4TH & COLUMBIA

DOWNTOWN DESIGN REVIEW BOARD

EARLY DESIGN GUIDANCE 2 - 03.01.16

PROJECT NO. 3020955

Levels 3-6 Residential & Above Grade Parking

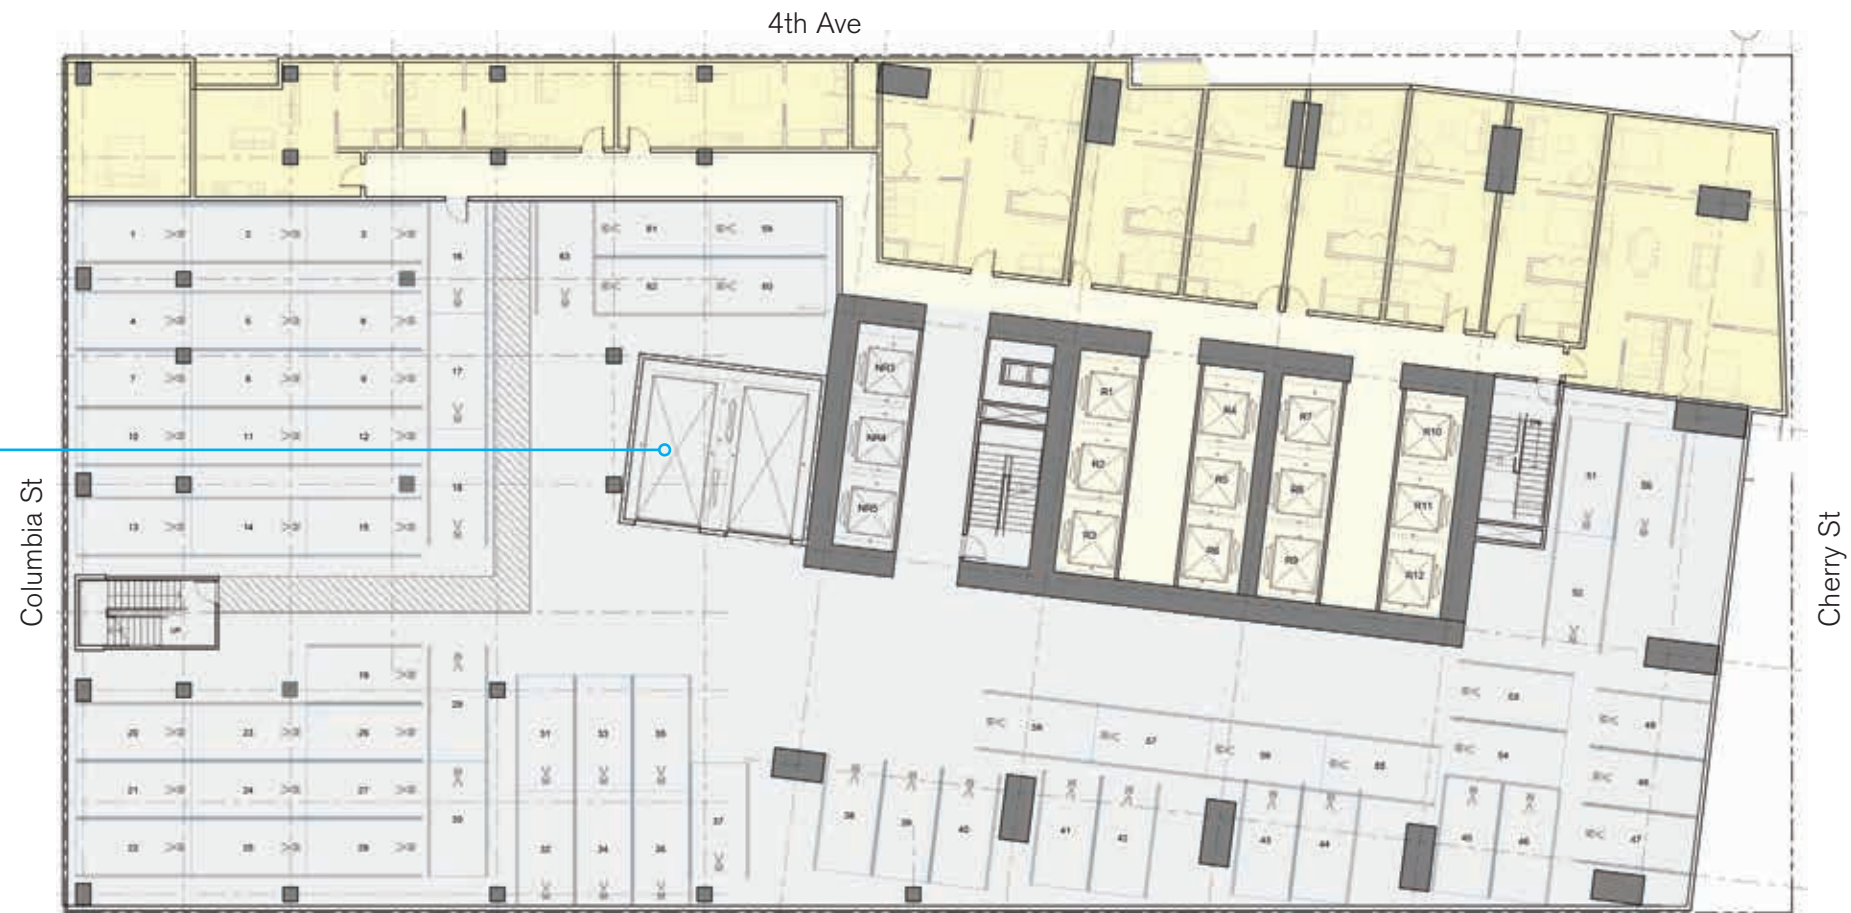
COMMENT 3A Above Grade Parking

RESPONSE – By adding two car elevators and converting these floors to **flexible flat-plate** construction with increased floor-to-floor height to 10', the area devoted to above-grade parking has been dramatically reduced, while all parking along 4th Ave and at the two intersections has been replaced with residential units. As a result, the massing of the tower and podium are more vertically integrated, with mixed and active uses along all facades, night and day. The residences at levels 3-6 extend the neighborhood concept to the base of the tower and create an active 24/7 presence in an office-dominant district. The updated proposal notably includes the elimination of the second curb cut and parking ramp on Columbia St, which frees up interior space at levels 1 and 2, as well as the addition of ground-level retail spaces to activate the street.

Car elevator with valet parking added to reduce ramps in above-grade parking

A View from 4th Ave looking South

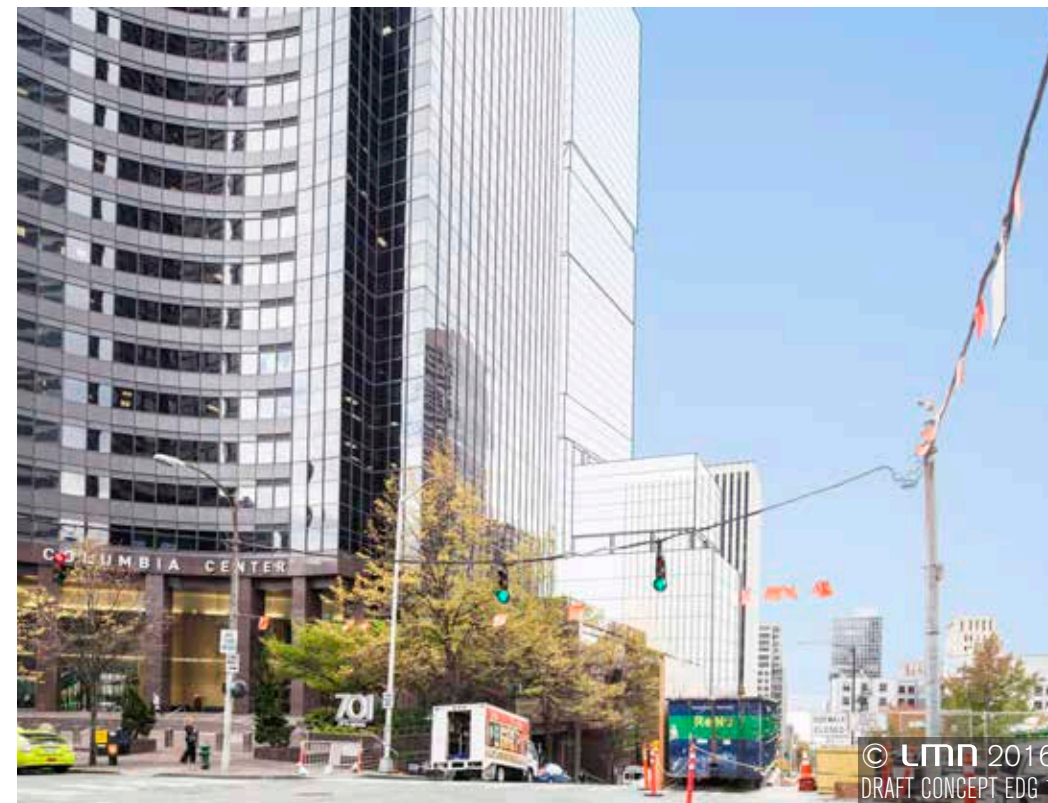
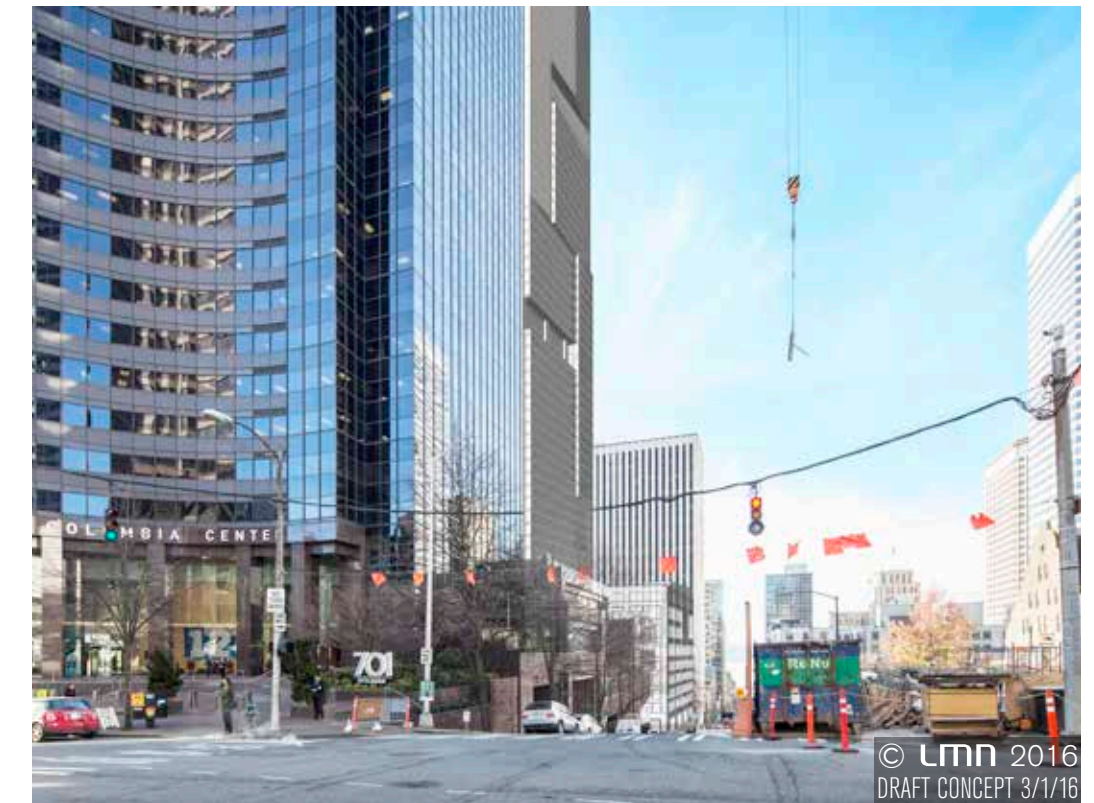
COMMENT 3C Podium in Context

RESPONSE – Additional street level views have been added to show how the podium design integrates into the existing context, as well as rendered elevations in the Current Proposal section.

Tower Top perspective view

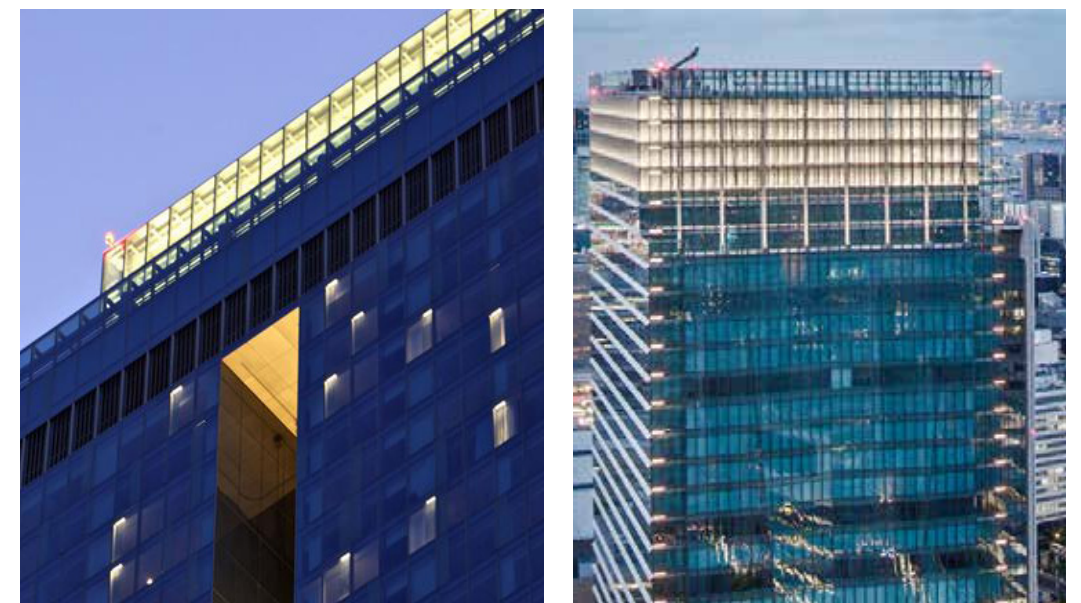
COMMENT 4C Tower Top Form

The Board supported a basically flat top tower, but agreed the materials should intentionally feather or transition to the sky, and a careful lighting design should create a subtle beacon. The parapets might step consistent with distinct program elements (see 4b) and/or the volumes below (see 5a), rather than be one rectangle with four sides of equal height. [A2]

RESPONSE – We have incorporated the suggestion of the Board and refined how the tower top meets the sky by feathering the top edges. The wind tunnel study performed at this part of the building indicated significant benefits to a 50% open parapet. This study informed our design decision of using a gradated, playful layout of perforated metal and glass panels transitioning from the glass and metal skin below, with openings to let air pass through. Continued refinement of the parapet screen materiality, rooftop equipment, and structural needs will inform the appropriate design of flexible lighting options and the night-time appearance of the building.

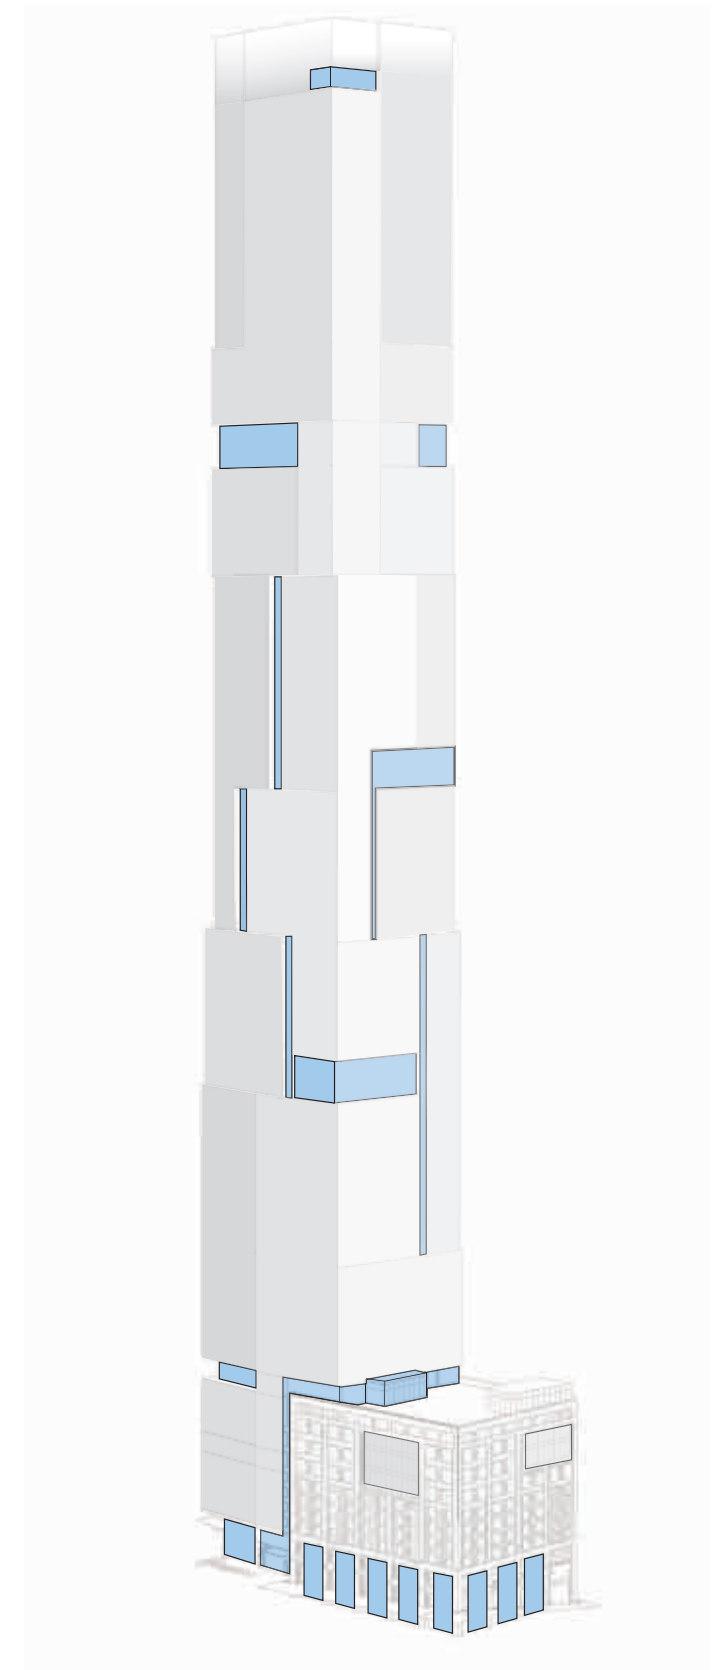
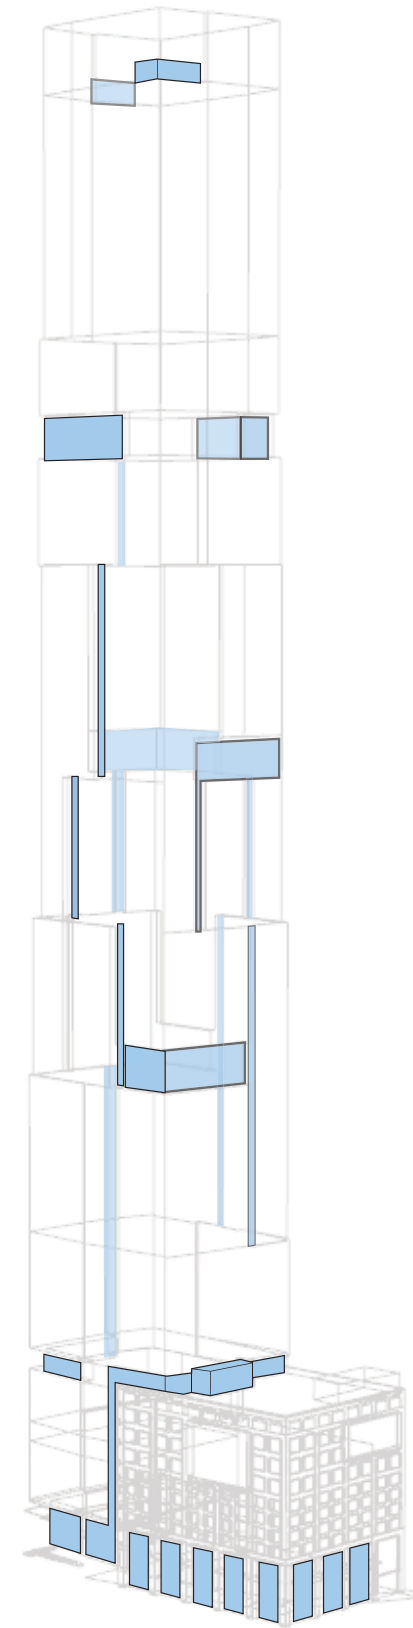
COMMENT 5B Tower Anchoring & Expression

RESPONSE – The design of tower has been developed to incorporate bold urban scale gestures and fine grain articulation at the podium to further modulate the facade, reinforcing the main concept of the 'vertical neighborhoods'. Additionally, layering and depth is expressed through a playful composition of the podium elevation, relating the tower to its context.

By stitching these interlocking volumes together with recessed vertical reveals, which also double as balconies, and horizontal reveals serving as amenity floors, the tower will stand out against a backdrop of monolithic and repetitive floor extrusion found in the surrounding neighboring office towers. A folded glass skin, which reflects light at varied angles to create a constantly changing appearance, expresses the diversity of these vertical neighborhoods and in turn also reflects the diversity of the city of Seattle. The tower's rotation and the language of the folded massing are carried from top to bottom, expressing a consistent design language that is apparent both up-close and from afar.
